ACCESS PLANNING REVIEW REPORT

PROJECT NAME: **Newcastle Art Gallery Expansion**
PROJECT ADDRESS: 1 Laman Street, Cook Hill NSW 2300 Australia, City of Newcastle
PROJECT STAGE: S4.55 Application
PROJECT NO: **GDL200261**
PREPARED FOR: Smith & Tzannes
DATE: **27.04.2021**

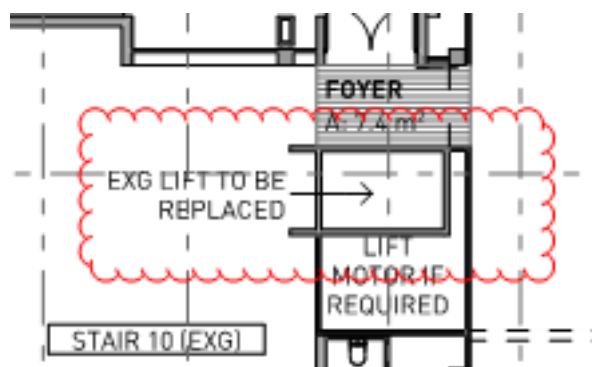
- a) The existing lift located adjacent to the existing gallery B is both for public access and transporting art works is to be replaced with a new fully accessible passenger lift. Detailed information such as lift shaft modification to suit the new lift is required. A new lift with a lift car dimension of 1400mm (W) x 1600mm (D) is recommended, due to its function and use for both communication and transportation. Further information such as lift specifications is also required for review prior to CC.

Principal entrance of the Café

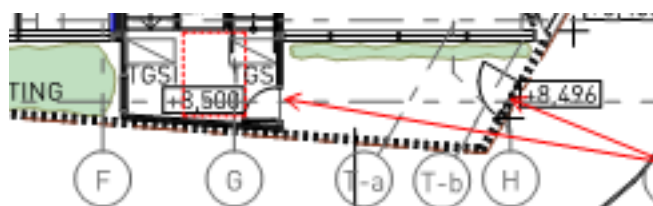
- All doors required to be accessible are to be documented to confirm required access features for people with disability including 850mm minimum clear width opening for active leaf, level threshold, circulation space, luminance contrast, glazing/visual indicators, where required, and door hardware in compliance with AS1428.1 to satisfy BCA D3.2. Door Schedule required as the project further develops.
- The principal accessible entrance sliding door into the ground floor Café does not have the required 395mm latch side clearance from the corridor side approach.

The existing lift located adjacent to the existing gallery B

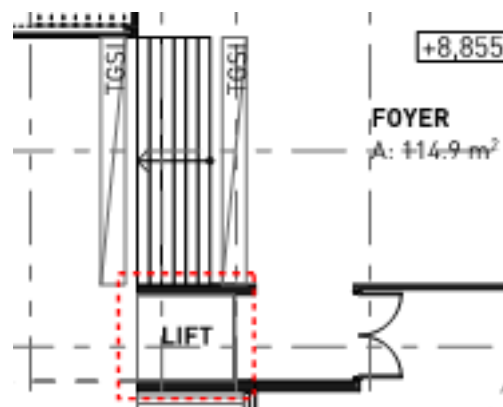
- a) The existing lift located adjacent to the existing gallery B is both for public access and transporting art works is to be replaced with a new fully accessible passenger lift. Detailed information such as lift shaft modification to suit the new lift is required. A new lift with a lift car dimension of 1400mm (W) x 1600mm (D) is recommended, due to its function and use for both communication and transportation. Further information such as lift specification is also required for review prior to CC.

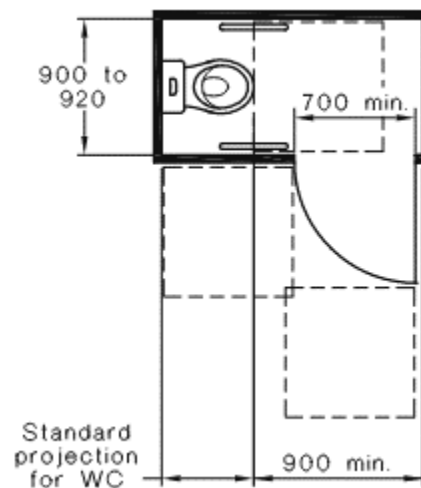
- a) The length of the partition installed in the male ambulant toilet appears to be less than the 840mm minimum as required by the standards to accommodate the location of the grabrail and the projection of the pan, details as per the figure below.

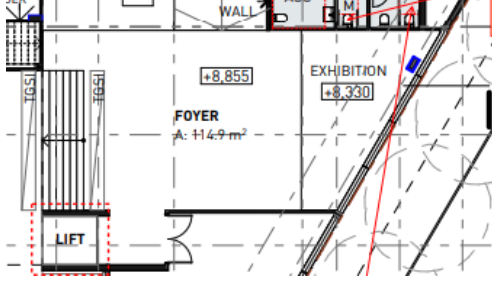
No.	DtS Non-Compliance	Potential Justification	Reference Clause	BCA Performance Requirement
1	<p>The sliding door into the shop has inadequate latch side clearance.</p> 	<p>Possible justification is as follows:</p> <ul style="list-style-type: none"> Consider automating the door to accommodate people with a disability. Door to be held open during business operational hours for ease of access for people with a disability. 	D3.1	DP1
2	<p>The foyer facing the entrance located off Laman street has a 525mm rise from the adjacent exhibition area, details as per the extract below:</p>	<p>A performance solution would be required to justify access to and though the subject foyer where the exhibition area is located via a management in use plan on an exhibition-by-exhibition basis. The following points are for consideration:</p> <ul style="list-style-type: none"> Safety in design consideration Headroom height clearance shall be 	D3.1	DP1 and DP2

No.	DtS Non-Compliance	Potential Justification	Reference Clause	BCA Performance Requirement
		2000mm at a minimum throughout the subject area in question.
